Addendum No. 1
May 3, 2022

Project: Webster Area School – 2022 CTE Addition & Remodeling
Webster, South Dakota
Architecture Incorporated Project #2936

Scope of this Addendum:

9.35-B1

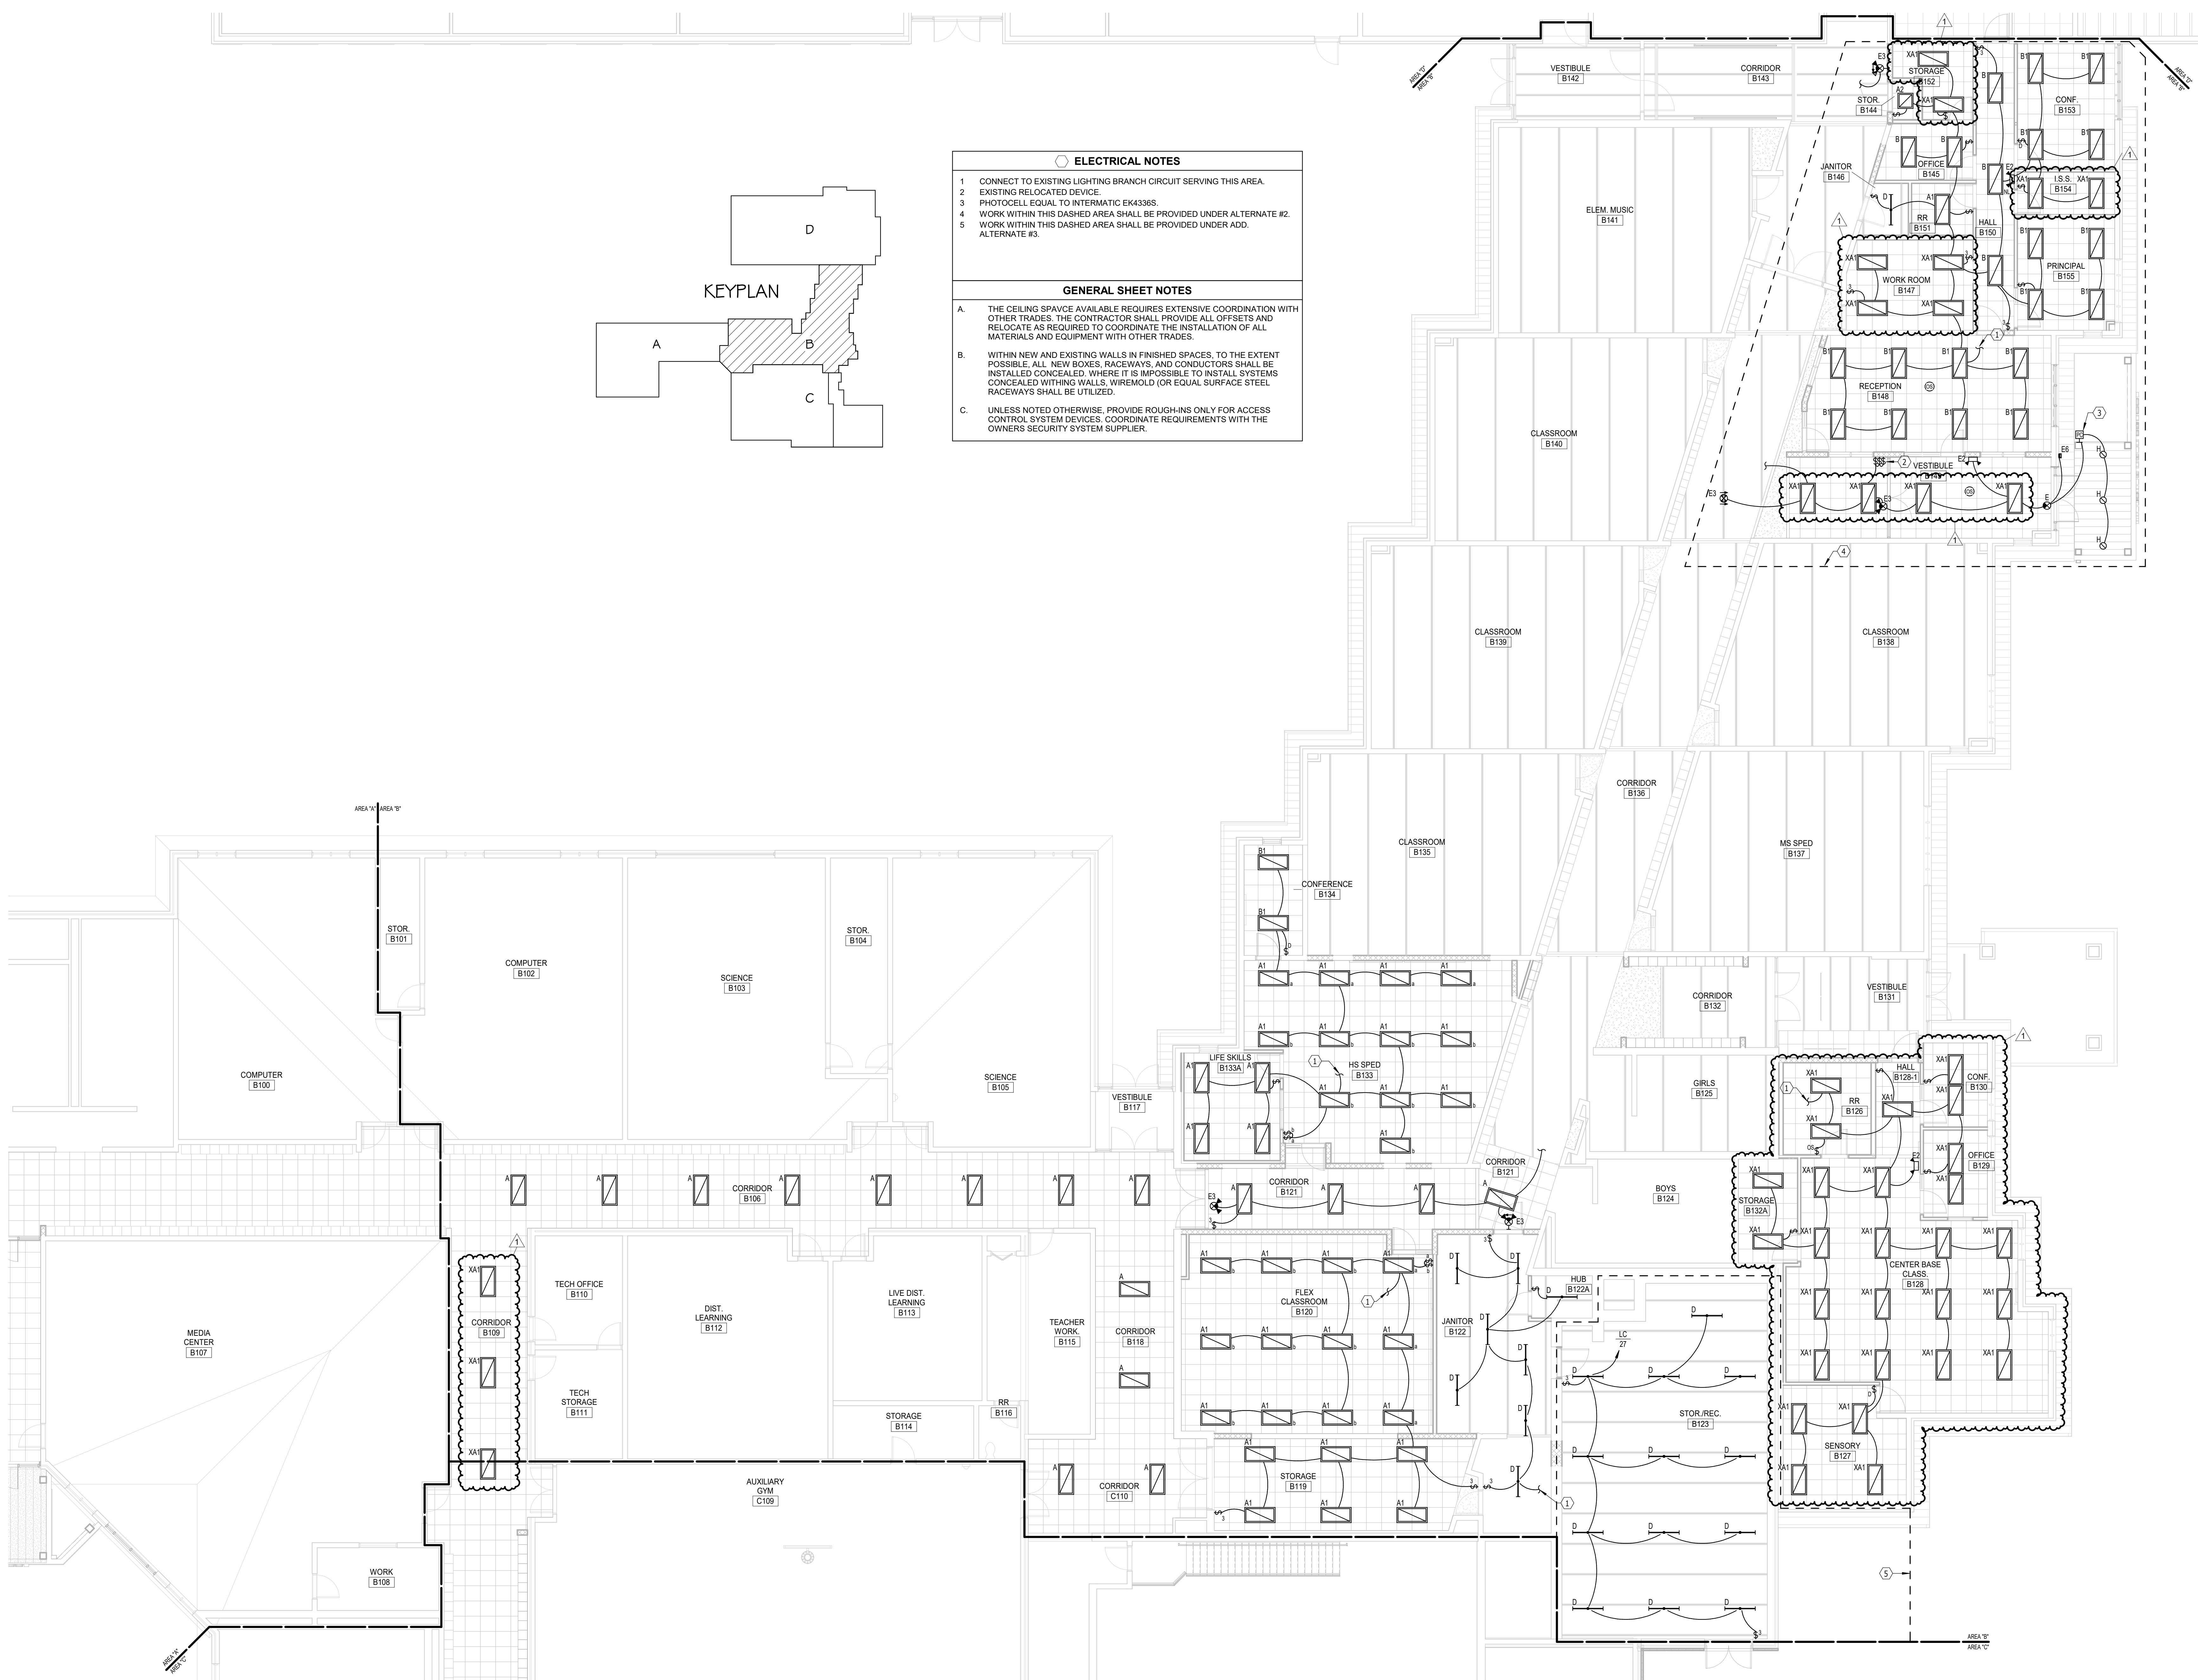
5) DRAWING SHEET 9.35-B1 – FLOOR PLAN – AREA B – LIGHTING

- a) See the attached revision drawing.

9.36-B1

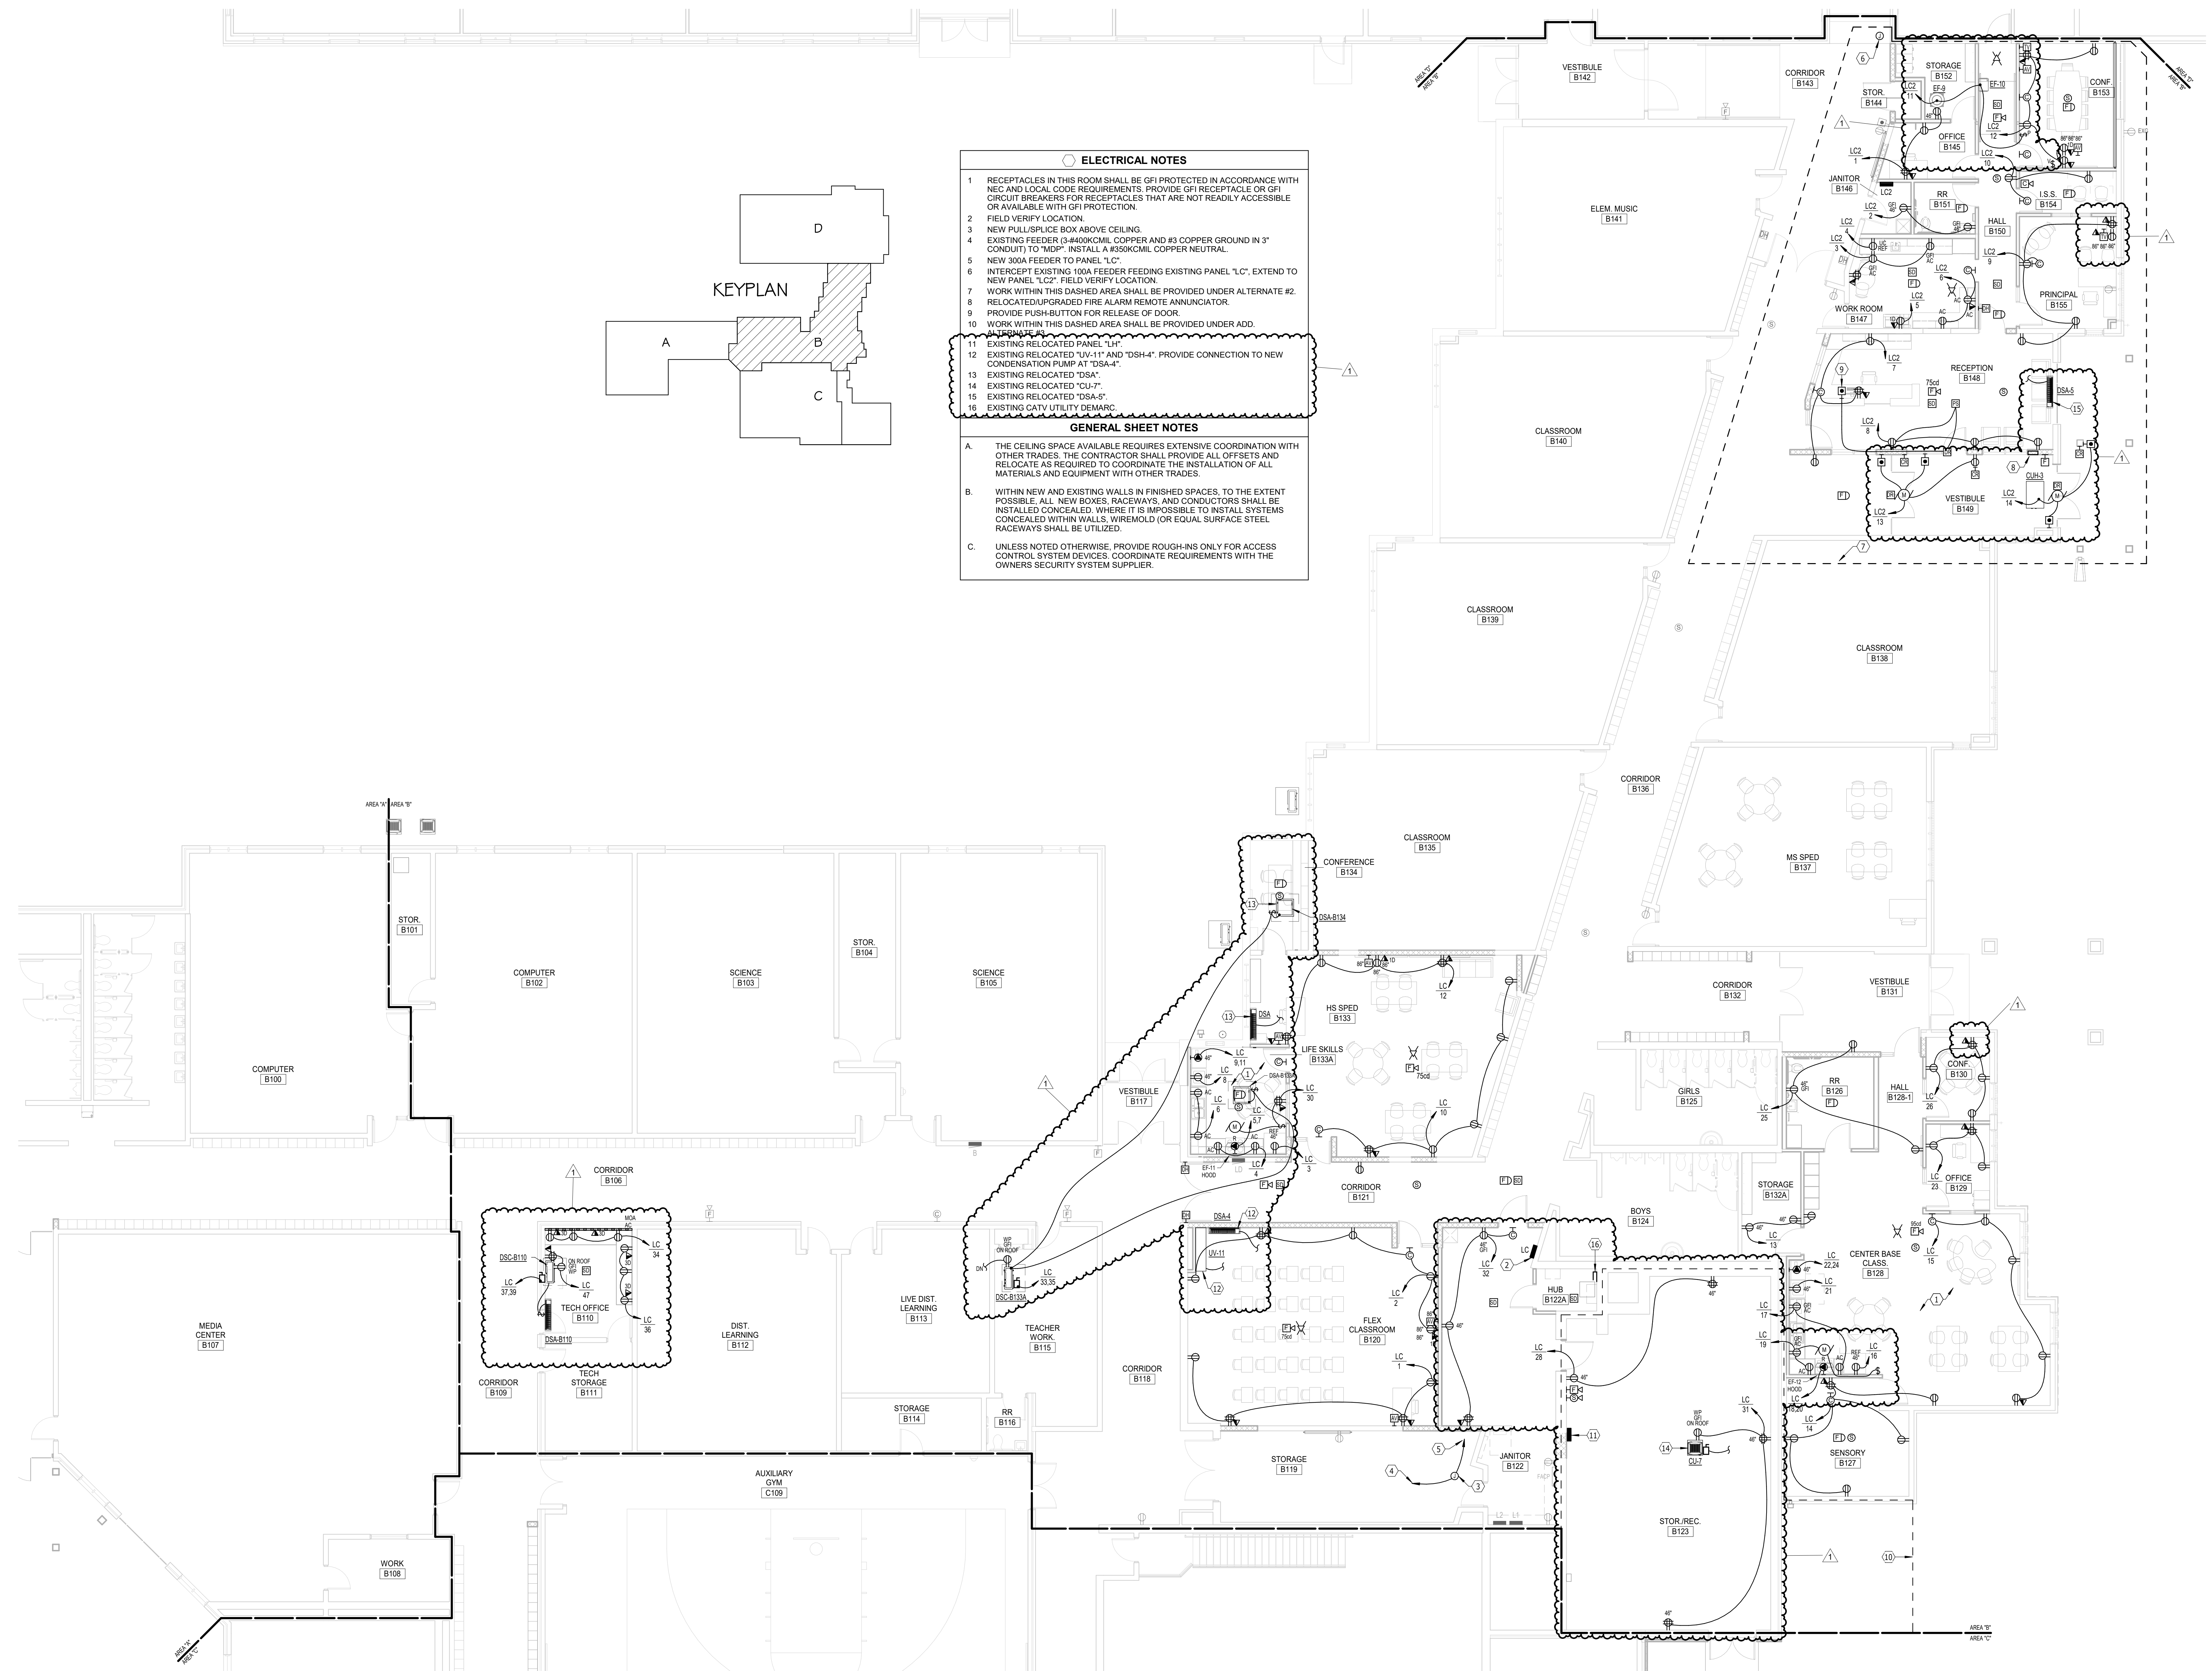
6) DRAWING SHEET 9.36-B1 – FLOOR PLAN – AREA B – POWER & SIGNAL

- a) See the attached revision drawing.

FLOOR PLAN - AREA C - POWER & SIGNAL

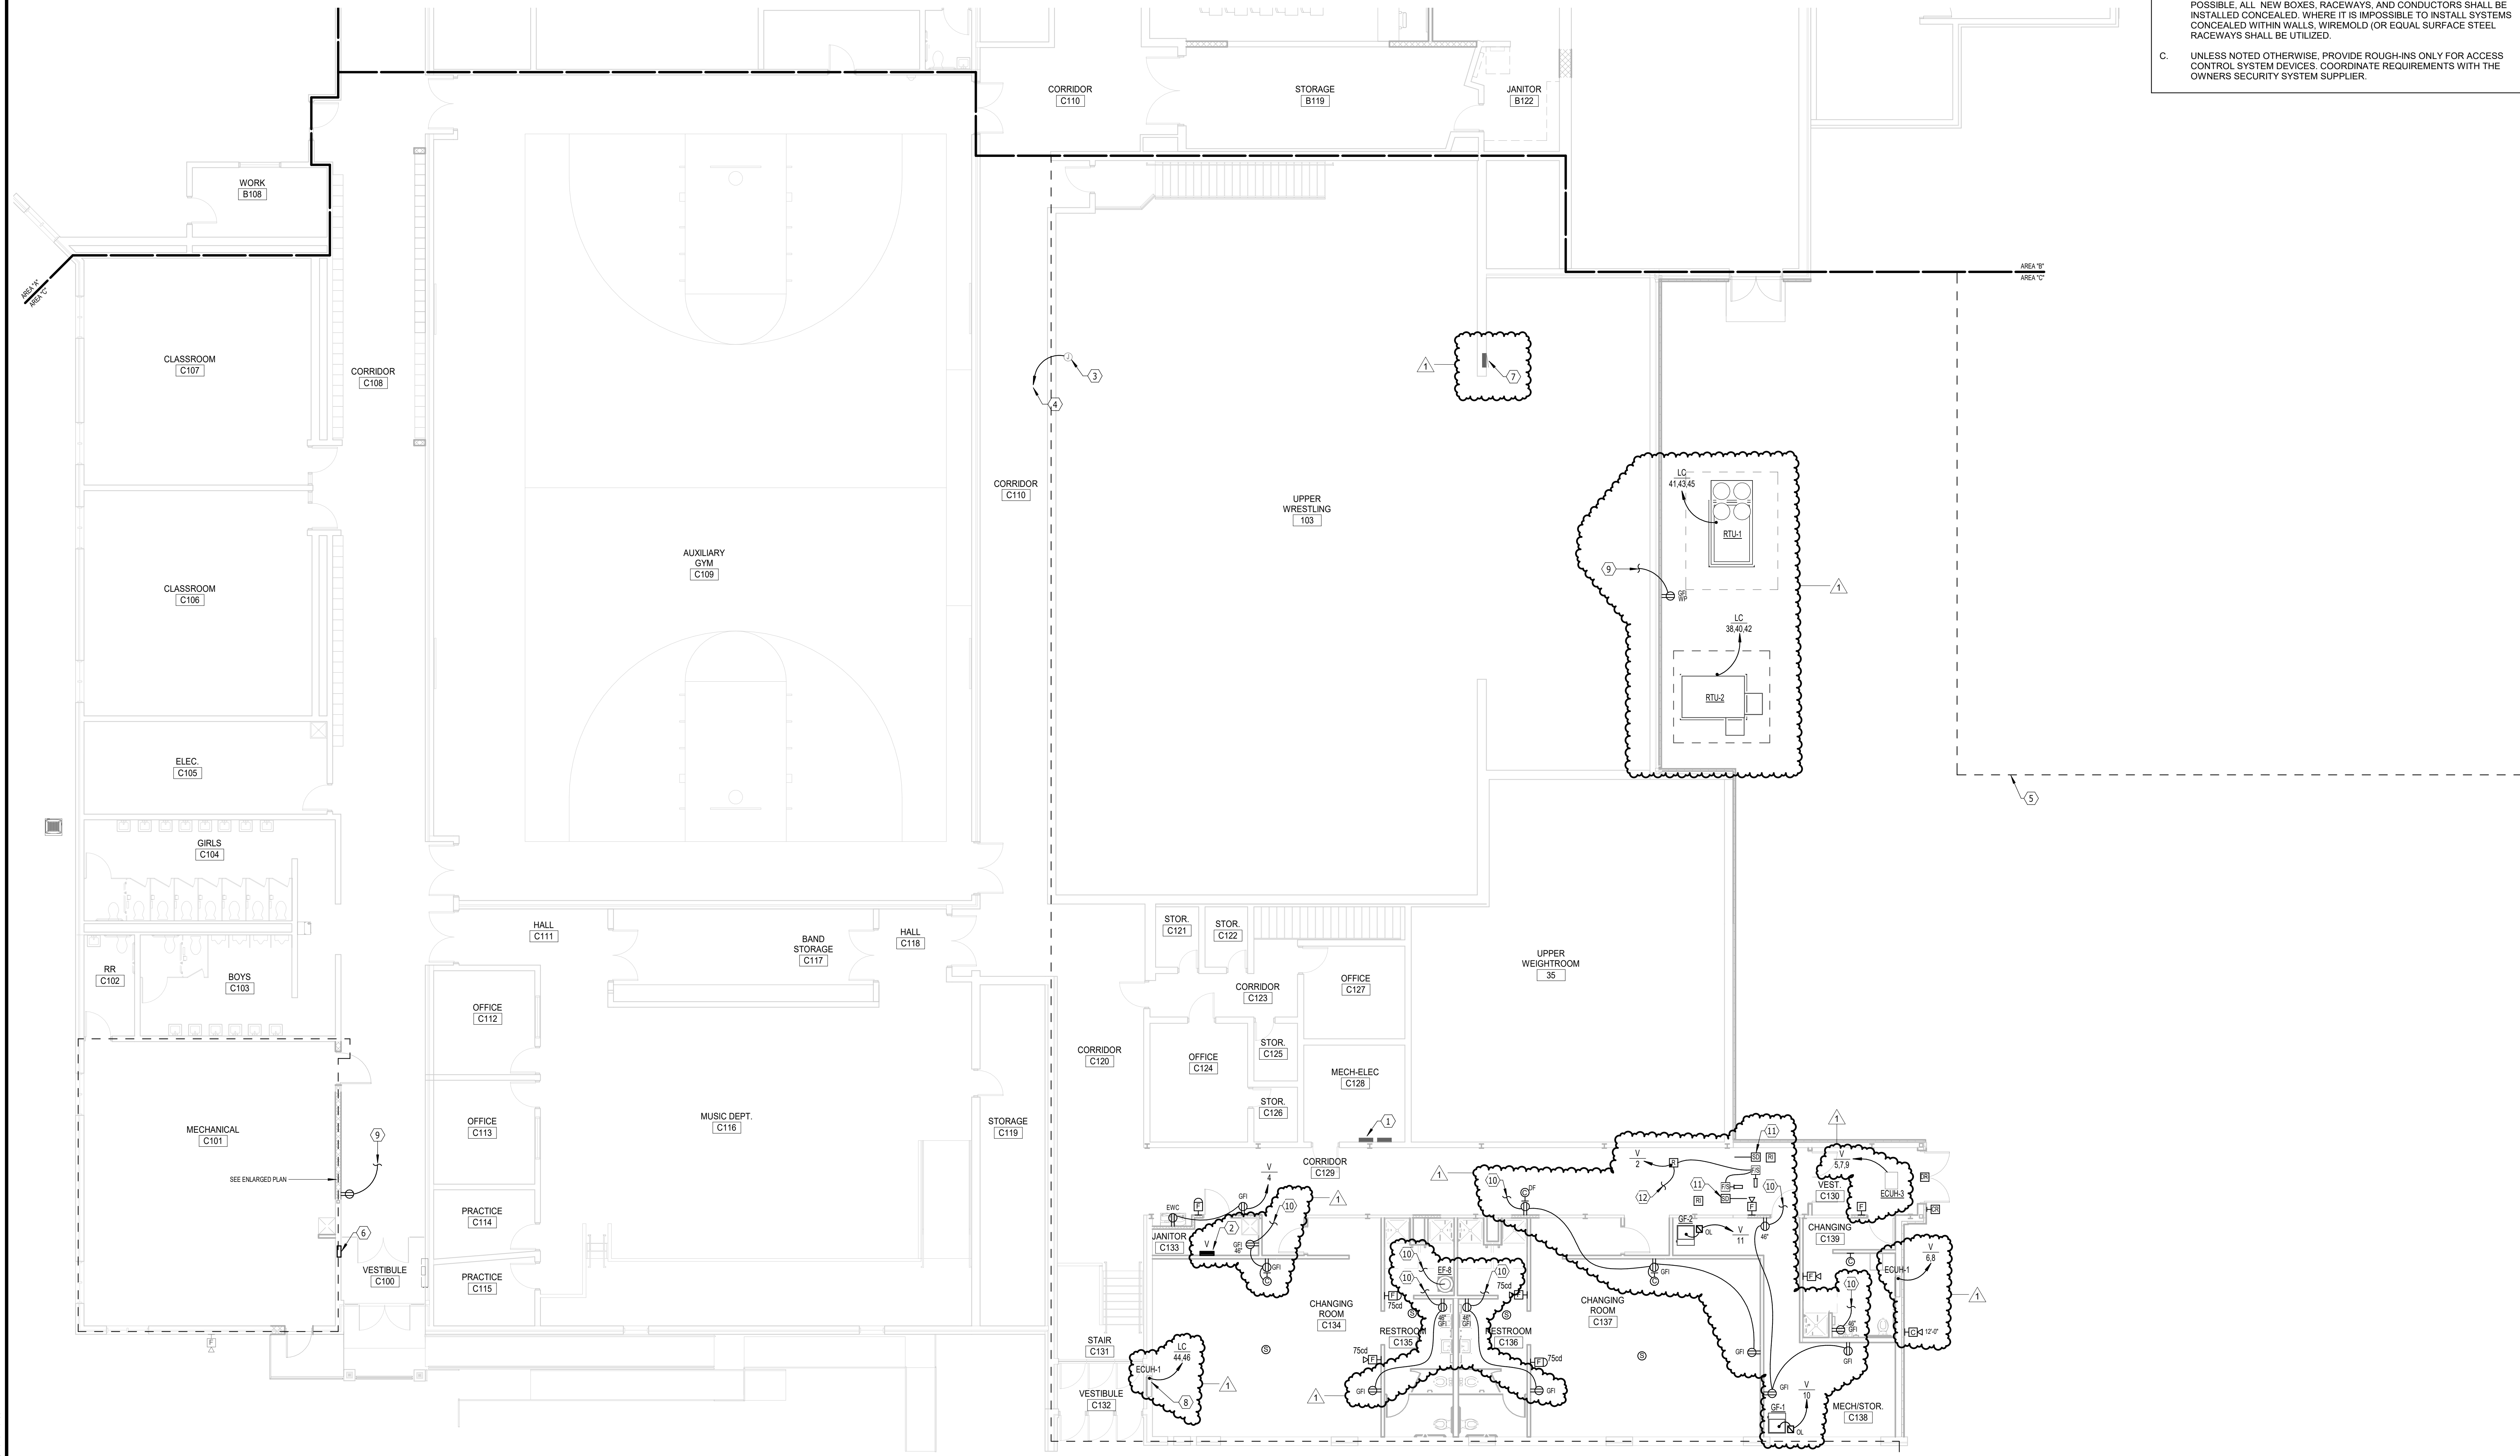
8) DRAWING SHEET 9.40-C1 – FLOOR PLAN – AREA C – POWER & SIGNAL

- a) See the attached revision drawing.
